CHAIN VALLEY COLLIERY – MODIFICATION 1

Response to Submissions

Section 96 Modification to SSD-5465

Prepared for LakeCoal Pty Limited
September 2014

FIGURE 3. Measured Time Dependent Subsidence Behaviour above Comparable GN Seam Workings (Reproduced Figure 8b from DGS 2014)

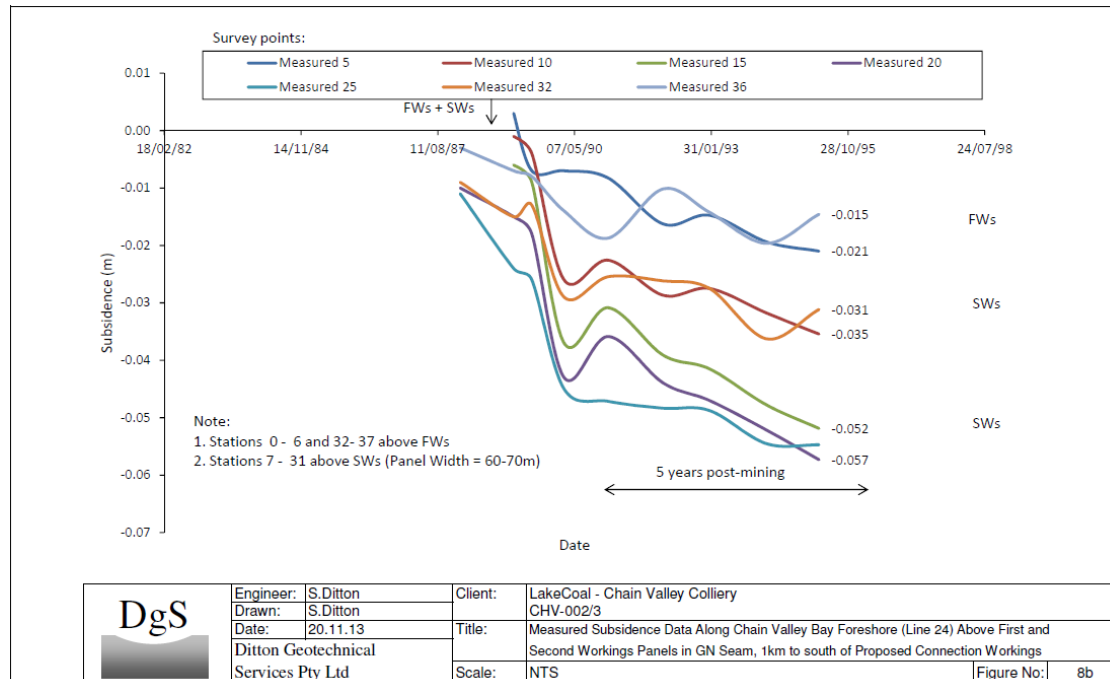
- (iii) A significant effort has been made to provide rational and logical explanation for previous unexpected surface subsidence “events” in the general vicinity, these relating to the time-dependent behaviour of soft floor measures directly beneath Great Northern Seam workings. Offering a credible explanation for measured time-dependent subsidence behaviour (see **Figure 3** as an example) that when it was occurring resulted in significant cause for concern as to long-term outcomes, is a significant contribution to the DGS impact assessment, particularly as it has been linked to a well-established

aspect of claystone stability under vertical loading, namely the exceedance of pre-consolidation pressures resulting in primary and secondary consolidation over time.

FIGURE 4. Predicted Subsidence Isopachs Due to the Formation of the Connection Headings in the Fassifern Seam and Surface Features (Reproduced Figure 18b from DGS 2014)

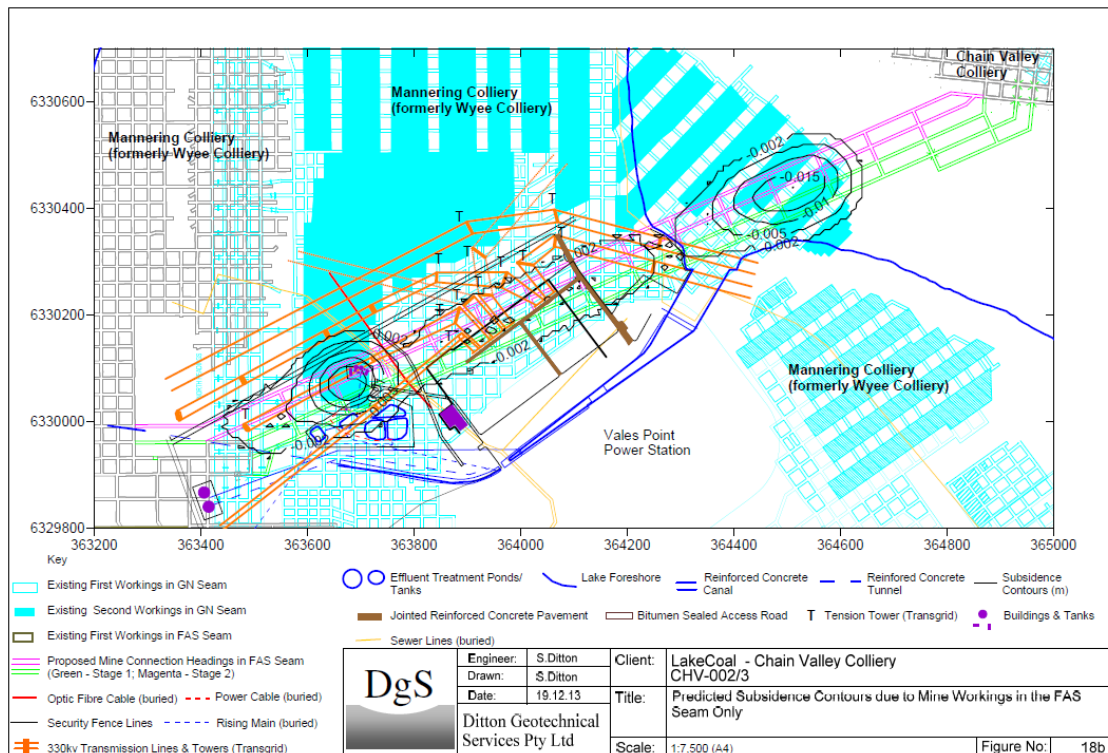
Figure 4 shows isopachs of the increase in surface subsidence as a direct result of forming the proposed connection headings along with the various surface features that are of relevance. This figure along with those detailing tilts, curvatures and strain provide a credible basis for assessing the likely impact on the various defined surface features due to the formation of the Fassifern Seam connection headings.

The TransGrid infrastructure of the Vales Point sub-station and nearby transmission towers (some of which are known to be tension towers) is situated above first workings in the Great Northern Seam such that the predicted increase in vertical subsidence as a result of forming up the proposed connection headings in the Fassifern Seam is 6 mm and less, again noting the conservative assumptions used by DGS when calculating these values. The associated maximum values of curvature, tilt and strain are $< 0.03 \text{ km}^{-1}$, $< 0.2 \text{ mm/m}$ and $< 0.3 \text{ mm/m}$ respectively. **Figure 4** also indicates that the majority of the TransGrid tension towers are located outside the 2 mm additional surface lowering isopachs so will be influenced by $< 2 \text{ mm}$ of vertical lowering due to the proposed mining.

FIGURE 3. Measured Time Dependent Subsidence Behaviour above Comparable GN Seam Workings (Reproduced Figure 8b from DGS 2014)

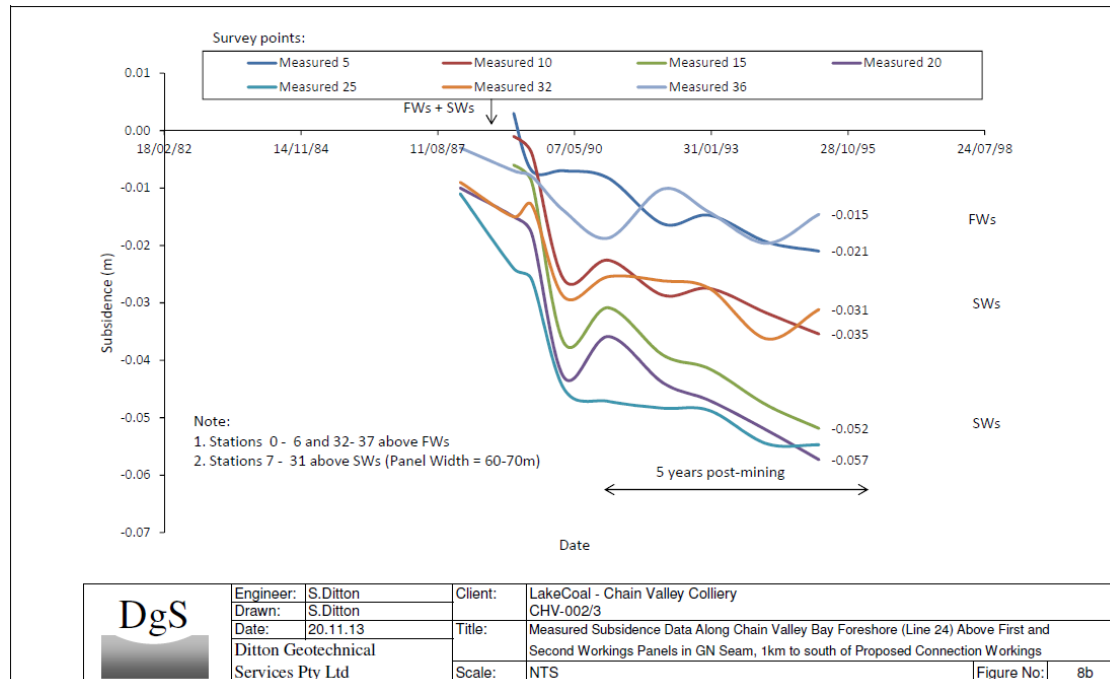
- (iii) A significant effort has been made to provide rational and logical explanation for previous unexpected surface subsidence “events” in the general vicinity, these relating to the time-dependent behaviour of soft floor measures directly beneath Great Northern Seam workings. Offering a credible explanation for measured time-dependent subsidence behaviour (see **Figure 3** as an example) that when it was occurring resulted in significant cause for concern as to long-term outcomes, is a significant contribution to the DGS impact assessment, particularly as it has been linked to a well-established

aspect of claystone stability under vertical loading, namely the exceedance of pre-consolidation pressures resulting in primary and secondary consolidation over time.

FIGURE 4. Predicted Subsidence Isopachs Due to the Formation of the Connection Headings in the Fassifern Seam and Surface Features (Reproduced Figure 18b from DGS 2014)

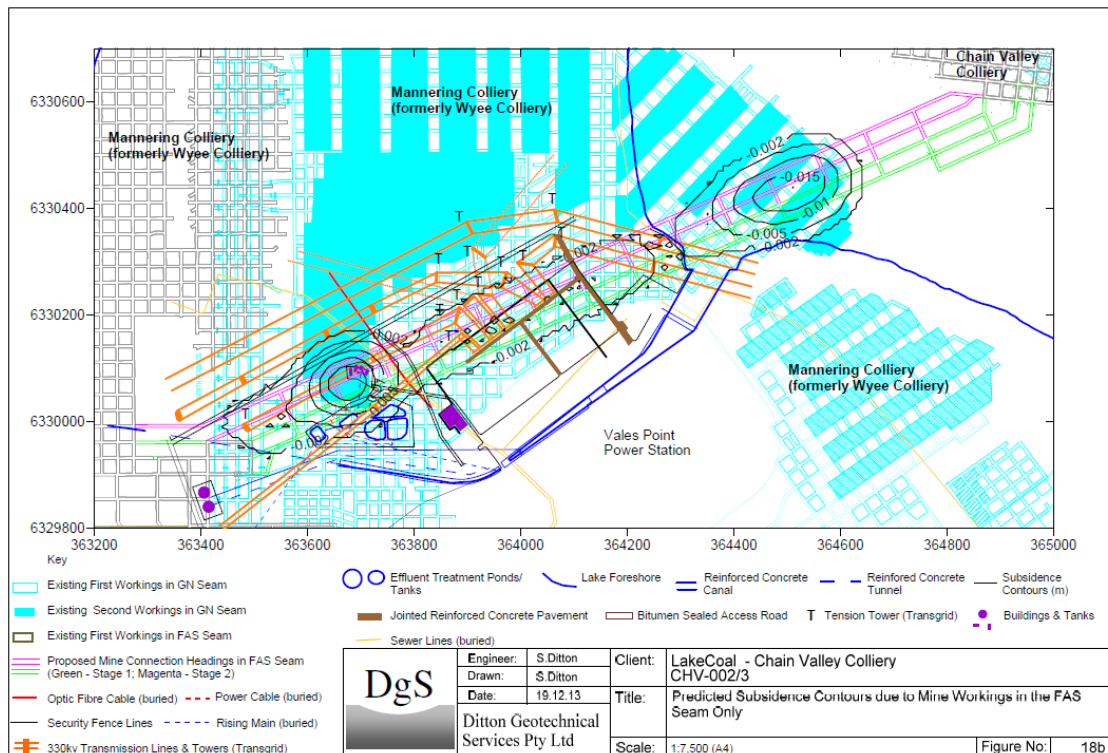
Figure 4 shows isopachs of the increase in surface subsidence as a direct result of forming the proposed connection headings along with the various surface features that are of relevance. This figure along with those detailing tilts, curvatures and strain provide a credible basis for assessing the likely impact on the various defined surface features due to the formation of the Fassifern Seam connection headings.

The TransGrid infrastructure of the Vales Point sub-station and nearby transmission towers (some of which are known to be tension towers) is situated above first workings in the Great Northern Seam such that the predicted increase in vertical subsidence as a result of forming up the proposed connection headings in the Fassifern Seam is 6 mm and less, again noting the conservative assumptions used by DGS when calculating these values. The associated maximum values of curvature, tilt and strain are $< 0.03 \text{ km}^{-1}$, $< 0.2 \text{ mm/m}$ and $< 0.3 \text{ mm/m}$ respectively. **Figure 4** also indicates that the majority of the TransGrid tension towers are located outside the 2 mm additional surface lowering isopachs so will be influenced by $< 2 \text{ mm}$ of vertical lowering due to the proposed mining.

Figure 4. Water level changes in a coastal lagoon with an entrance open to coastal waters.

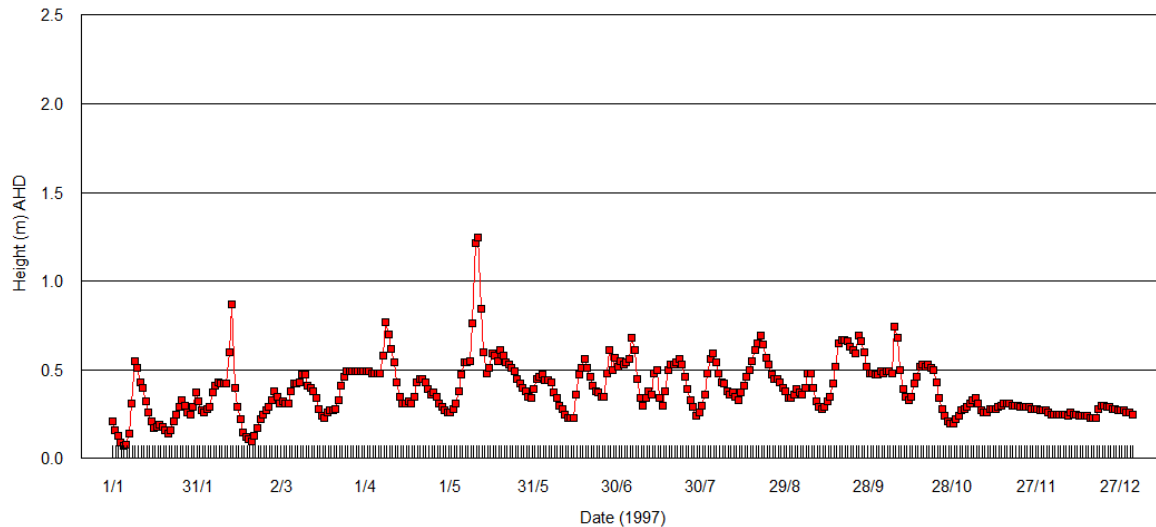
This statement suggests that Lake Macquarie is a static system and that 20mm of subsidence will allow saltwater from the lake to penetrate further inland to affect sensitive vegetation. As shown in Figure 4, extreme events can raise the water level of Lake Macquarie to around 1.3m above AHD allowing saltwater to penetrate far inland in low lying areas of the foreshore. On a monthly basis, changing atmospheric pressure means that the water level of Lake Macquarie can cycle between 0 and 0.7m above AHD. On lee shores wind wave set up can raise the water level of the lake to even higher levels for short periods. Furthermore, high wind waves can deposit a thick band of vegetable detritus and sand that acts as a dam along the shoreline that prevents accumulated saltwater from draining out of wetlands for several days. It is also noted that humans have occupied much of the shoreline of Lake Macquarie. Native vegetation has been stripped from the lake perimeter, seawalls built and in many places lawn mowers can operate to the water's edge. The land controlled by CVC and Vales Point Power Station, and the subject of this application, still contains several hundred metres of low lying natural vegetation in good condition. A subsidence of 20mm or 'zero subsidence, is highly unlikely to have any measurable effect on this remaining vegetation as the elevation of the land rises behind the shoreline.

Figure 5A. Mean percentage changes in PAR with depth at Station 1 - Wyee Point over 12 months. **Figure 5B.** Actual percentage changes in PAR at Station 1 - Wyee Point on the morning of 21-4-83.

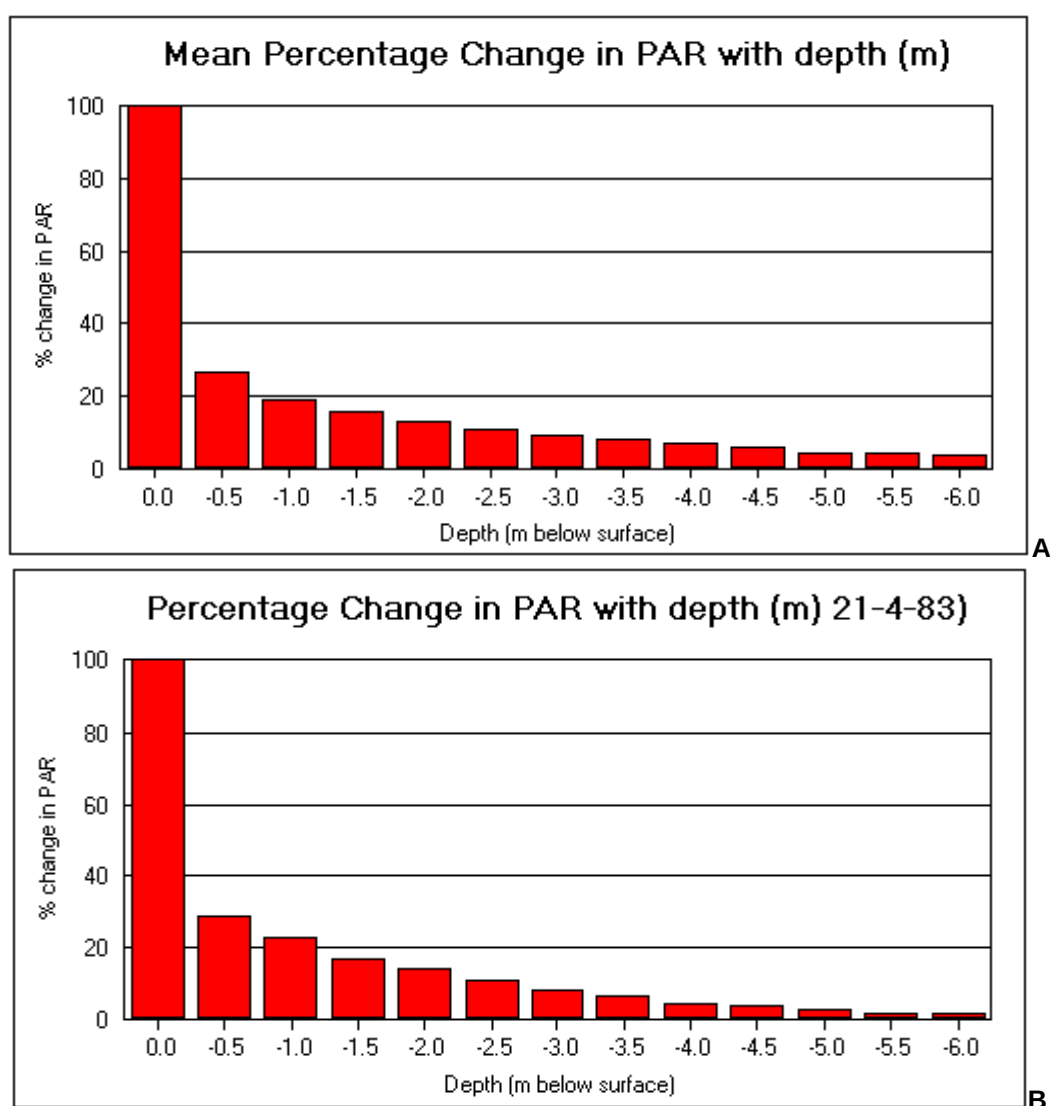
The seagrass beds in the area monitored for CVC ranged in depth of 0.5 to 2.12m below AHD. Only 14% of the surface light reaches the sea bed at 2.0m below AHD (Figure 5). Extending to slightly deeper depths are patches of filamentous algae. Seagrass beds in Chain Valley Bay and off Summerland Point may extend between 16.3 and 152.7m off shore as a continuous meadow (Laxton and Laxton 2014). At the offshore edge of the seagrass beds, the lake bed drops quickly to 6m below AHD. This is the location of the mud basin which occupies most of Lake Macquarie. At this depth only between 2 and 4% of the surface light penetrates to the lake bed. The surface of the mud basin was very fine silt, but buried in mud were vast quantities of intact bivalve and gastropod shells (Laxton and Laxton 2014a).
